**APPLICATION OF APACHE CORPORATION FOR  
AN ADJUDICATORY HEARING TO CONTEST  
THE DIVISION'S CONDITIONS OF APPROVAL  
ON APACHE CORPORATION'S SCOPE OF WORK  
FOR ADDITIONAL INVESTIGATION,  
LEA COUNTY, NEW MEXICO.**

**APPLICATION FOR ADJUDICATORY HEARING**

**Re: Apache Corp., EBDU #37 Incident NDHR1922141227 (1RP-5636) - Scope of Work for Additional Investigation, Lea County, New Mexico**

RE: Additional Groundwater Delineation Work Plan  
Apache Corporation  
EBDU #37  
Case No. (1R-5636), Incident ID NDHR192214227  
Lea County, New Mexico  
Terracon Project No. KH247030

**EXHIBIT 1**  
**SITE MAP**

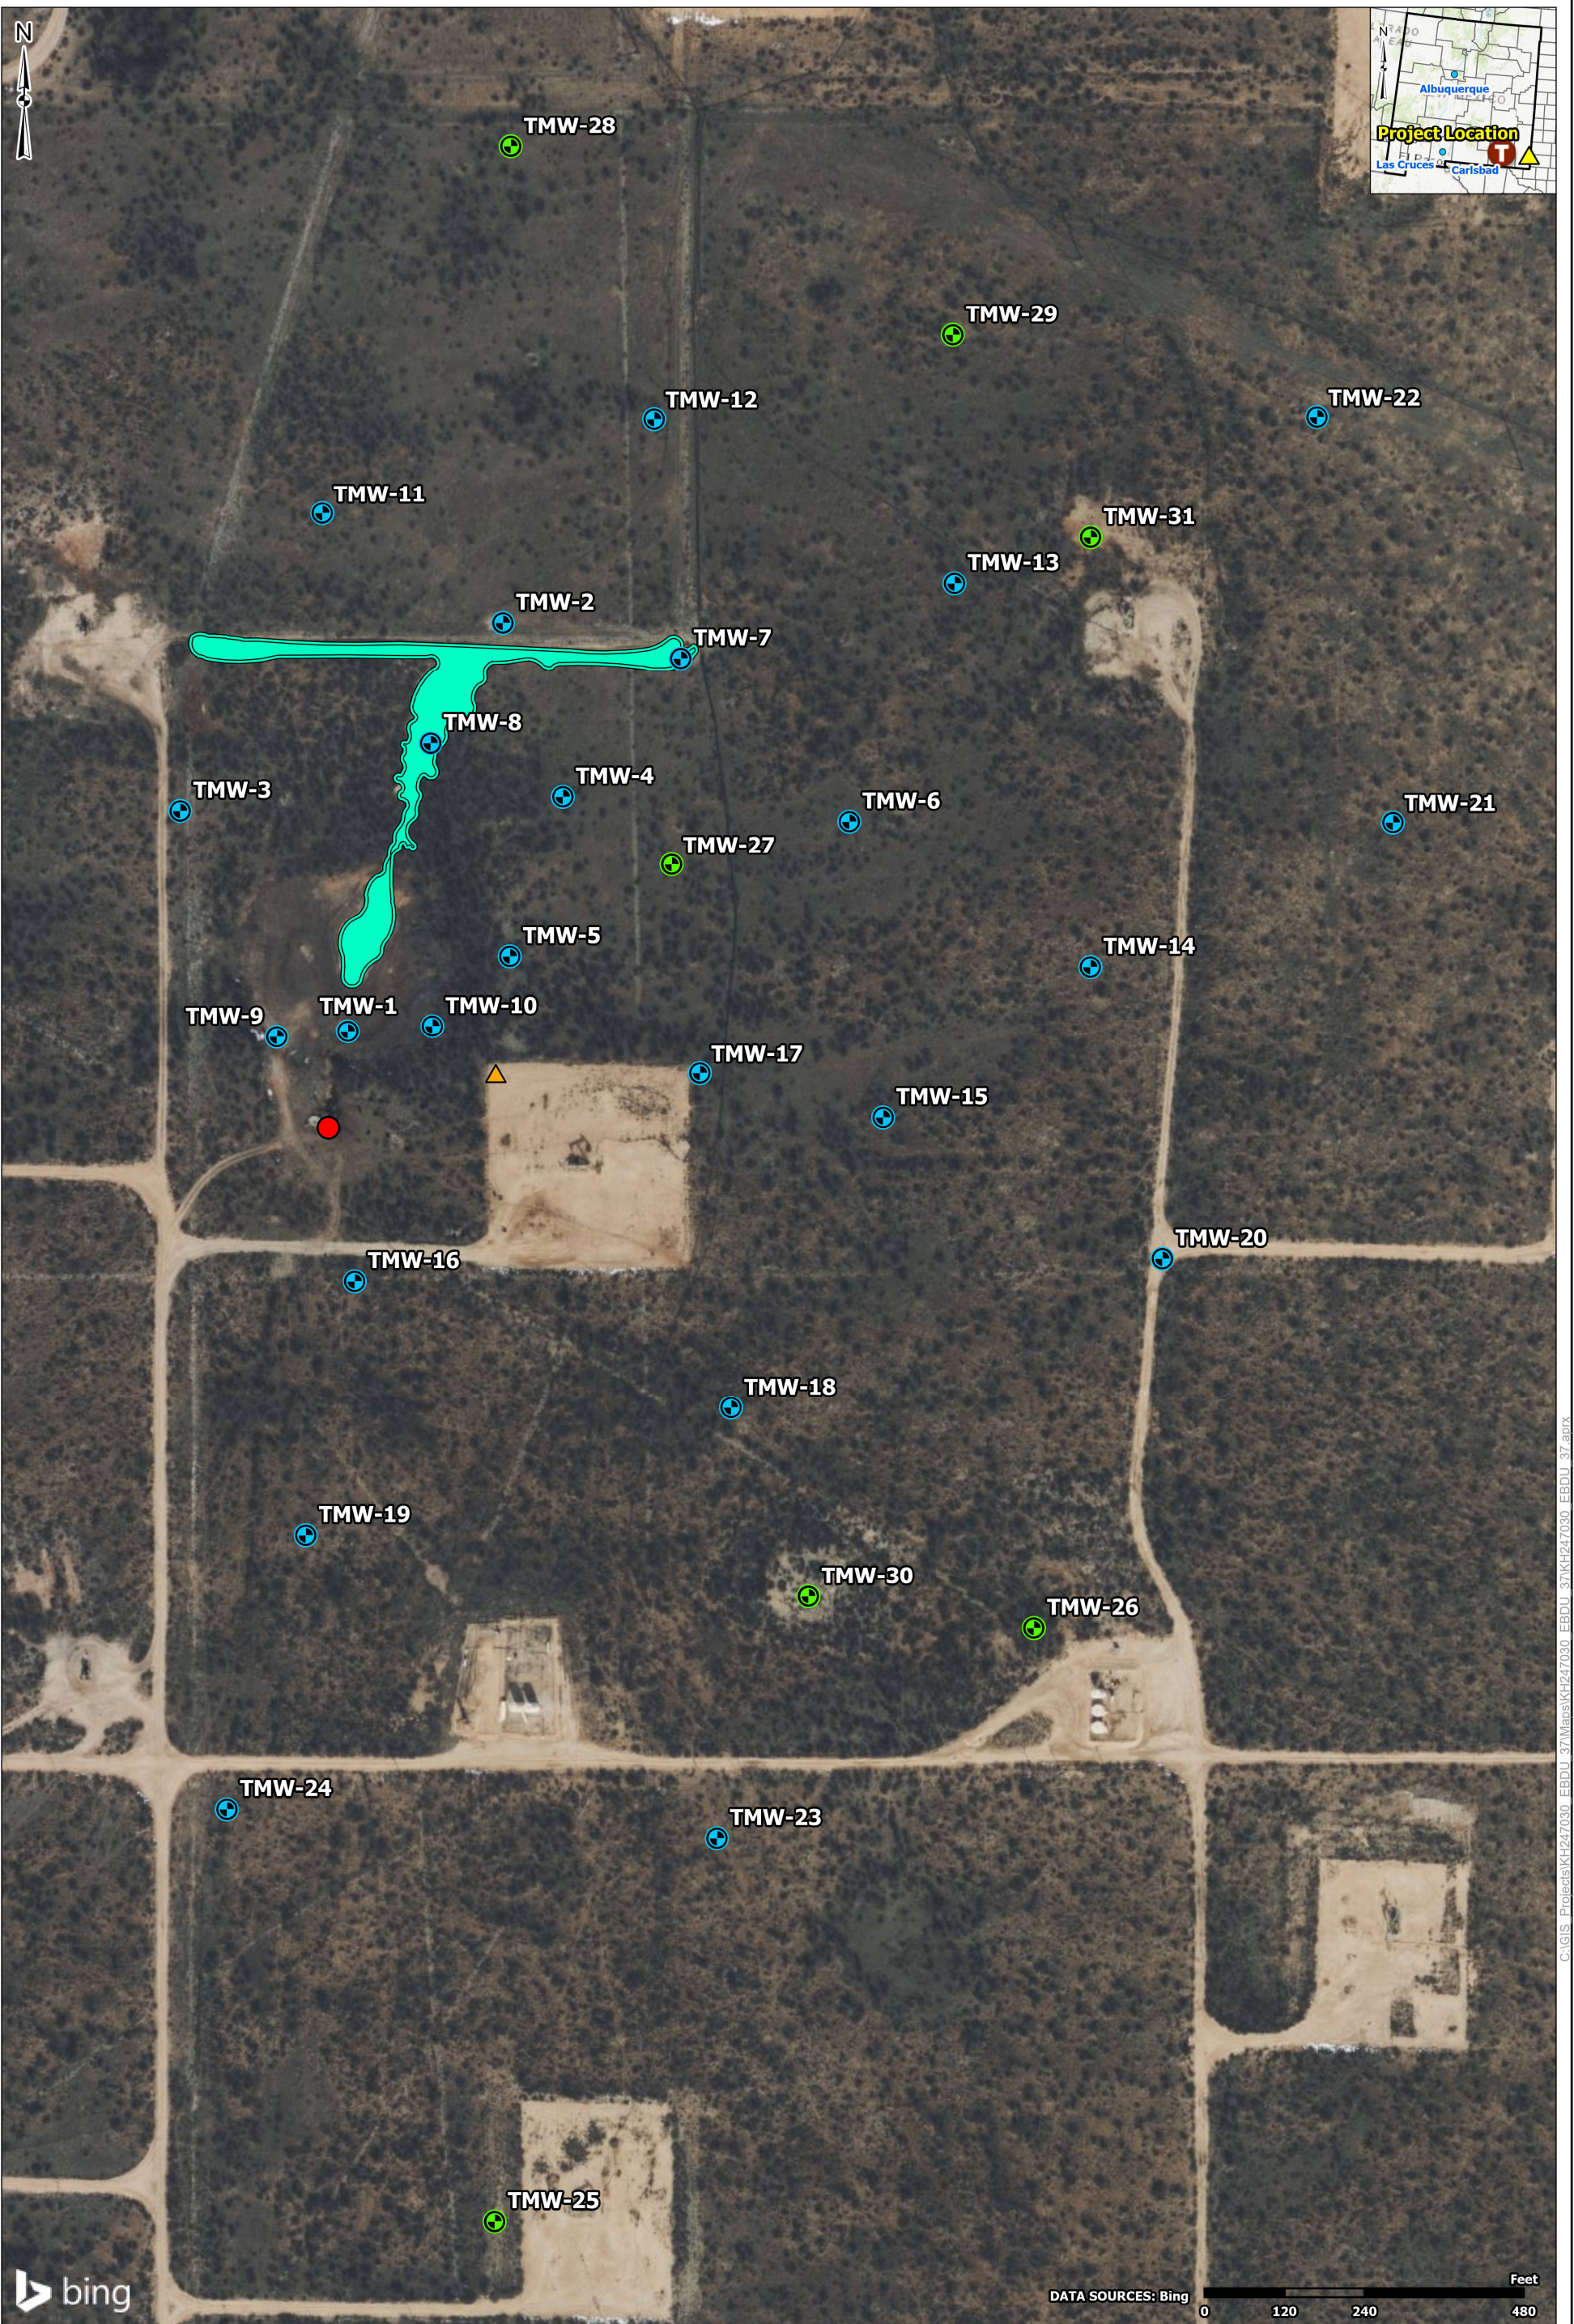
- TMW-30 ( 32.477428°, -103.120114°) will be located approximately 200 feet southeast of TMW-18 to provide information on stratigraphy and groundwater chemistry in the space between current TMW-18, TMW-23, and proposed TMW-26. This is the location identified as TMW-39 from the OCD approval letter.

- TMW-31 (32.476425°, -103.119734°) will provide downgradient and lateral (southeast) delineation of the plume. This is the location identified as TMW-42 from the OCD approval letter.
